STAFF REPORT
COMMUNITY DEVELOPMENT DEPARTMENT

HEARING DATE: 2/9/2021
 TO: Mayor & City Council
 FROM: Joe Dodson, Associate Planner
 208-884-5533
 SUBJECT: H-2020-0099
 Mile High Pines
 LOCATION: The site is located in the southwest corner of N. Ten Mile Rd. and W. Pine Ave., in the NE ¼ of the SE ¼ of Section 10, Township 3N., Range 1W.

I. PROJECT DESCRIPTION

B. Preliminary Plat (dated: 10/21/2020 12/28/2020)

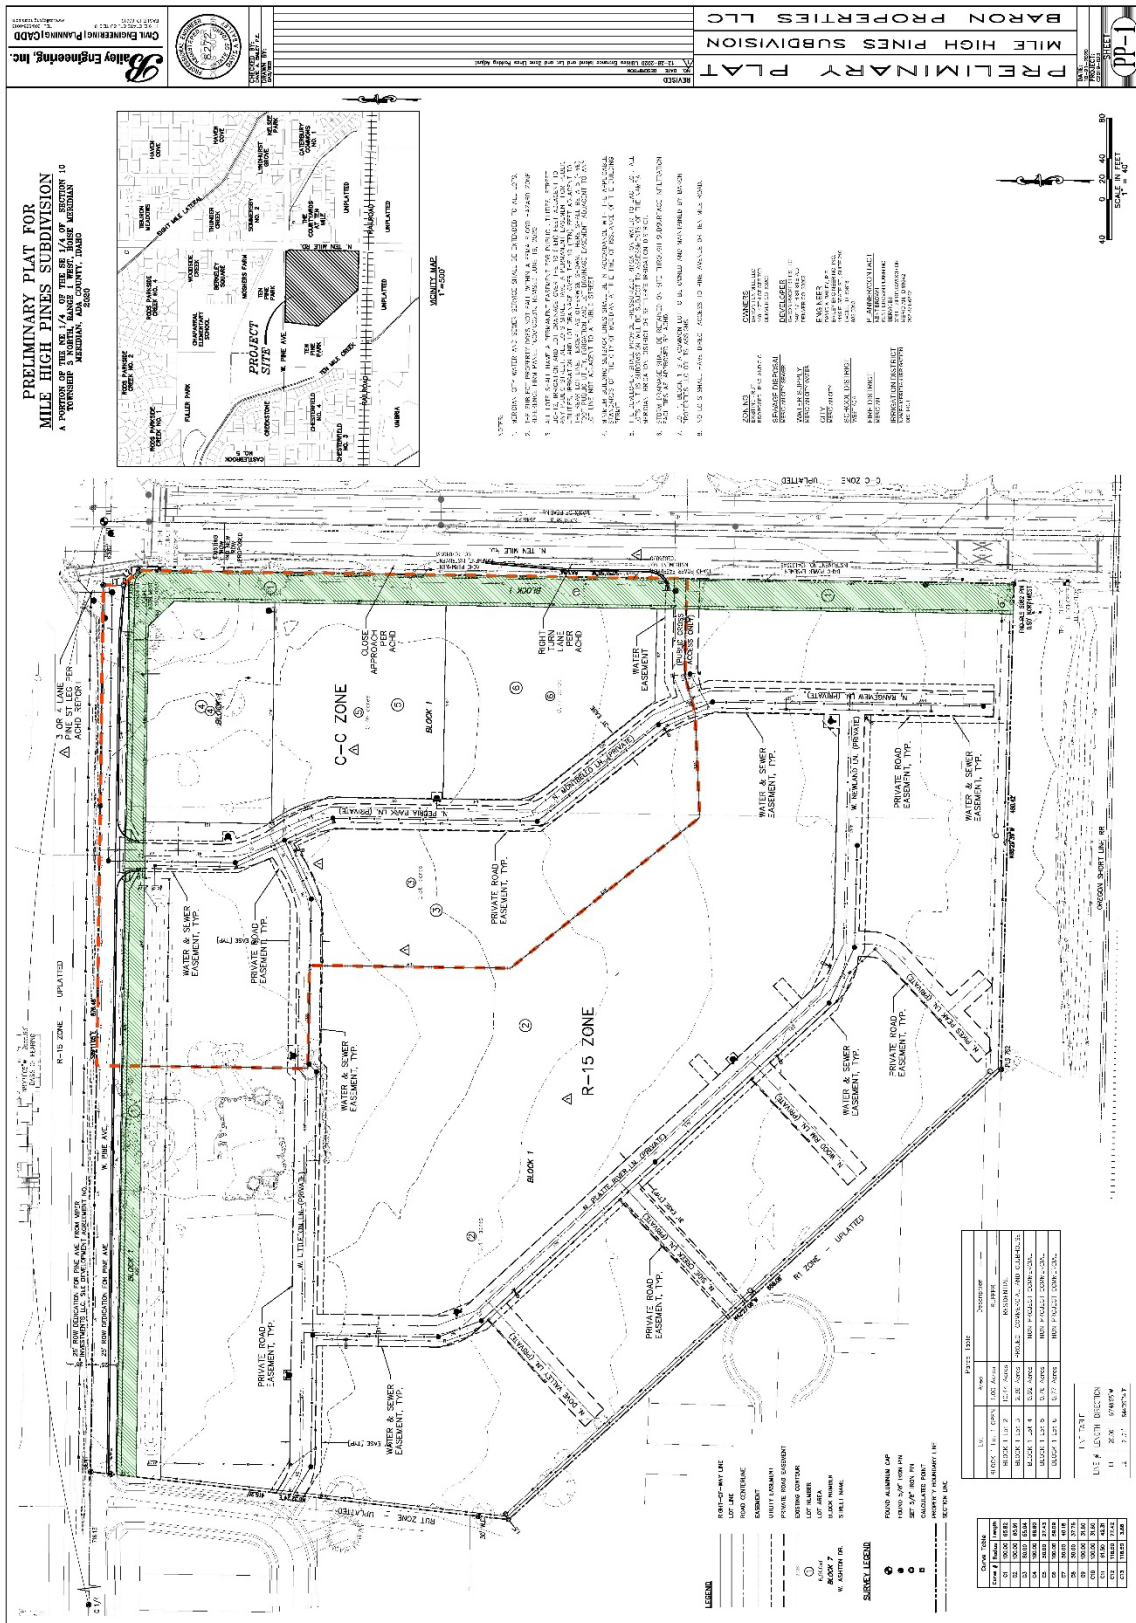
appear to meet the UDC requirements of this section except for subsection 3.e regarding easements – this is of great concern to Staff. The proposed project must comply with the separation requirements for all utilities and storm drainage lines while not having any permanent structure encroachments or overhangs within the easement. Public Works has raised concerns regarding whether the Applicant can comply with their easement requirements. Staff is adding a condition of approval to obtain Public Works approval of their utility plan prior to City Council to ensure any revisions required to the overall site design can be analyzed by Planning Staff for compliance with the UDC.

In response to Staff's initial discussions with the Applicant regarding this concern, the Applicant has provided a specific exhibit (see Exhibit VIII.L) to address this issue. Staff has done an initial analysis of this exhibit and it does not comply with all of the Public Works requirements. Planning staff also has concerns on whether an alternative compliance request may be needed in order to further revise the utilities for this development. As further revisions occur, the Applicant should also revise any other relevant plans and ensure they maintain compliance with all UDC requirements.

3. The preliminary plat included in Section VII.B, dated ~~October 24~~ December 28, 2020, shall be revised as follows at least ten (10) days prior to the City Council hearing prior to final plat submittal:

- a. If any changes must be made to the submitted plans to accommodate Public Works easement requirements, the Applicant shall submit all relevant and revised plans to the City of Meridian Planning Division for review.

D. Landscape Plans (date: ~~9/29/2020~~ 12/30/2020)

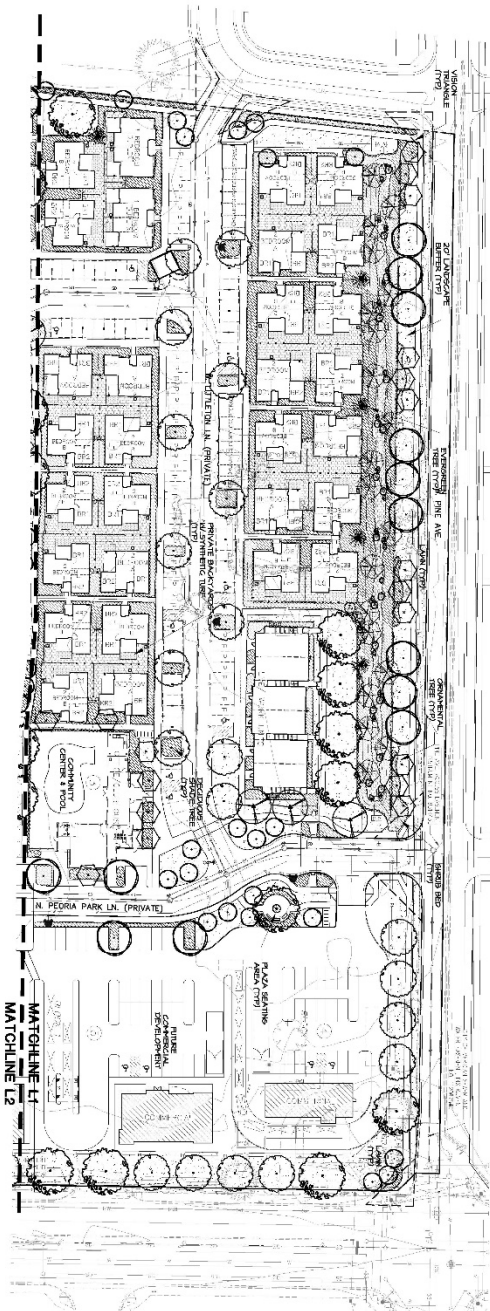
Landscaping is required along all pathways (including micro-pathways) in accord with the standards listed in *UDC 11-3B-12C*. The total lineal feet of *all* pathways with the required and proposed number of trees are NOT included in the Landscape Calculations table on the submitted landscape plans, sheet L.4. The table contains this data for the multi-use pathway but not the micro-path along the west perimeter of the development **and there does not appear to be trees located on both sides of either pathway segments. The addition of this data in the calculations table and the required trees located on both sides of the pathways will be required as a condition of approval. In addition, there does not appear to be the minimum 5 feet wide planter width on the south side of the multi-use pathway. The submitted landscape plans appear to show an area wide enough for the pathway and 5 feet of landscaping on both sides; the Applicant should revise the landscape plans to show compliance with these standards.**

The proposed C-C zoning district requires a 25-foot landscape buffer to any residential district; the submitted plans do not show compliance with this requirement. Because this is a mixed-use development and there is the presence of some landscaping, a sidewalk, and the street between the residential uses and the commercial, Staff does not have particular concern over this discrepancy. However, in order to comply with the UDC, the Applicant will have to request a waiver from City Council to reduce this buffer to the buffer shown on the submitted landscape plans.

4. City Council change(s) to Commission recommendation:
 - a. Council granted the requested waiver to reduce the required landscape buffer between the C-C zone and the R-15 zone to what is shown on the landscape plans.
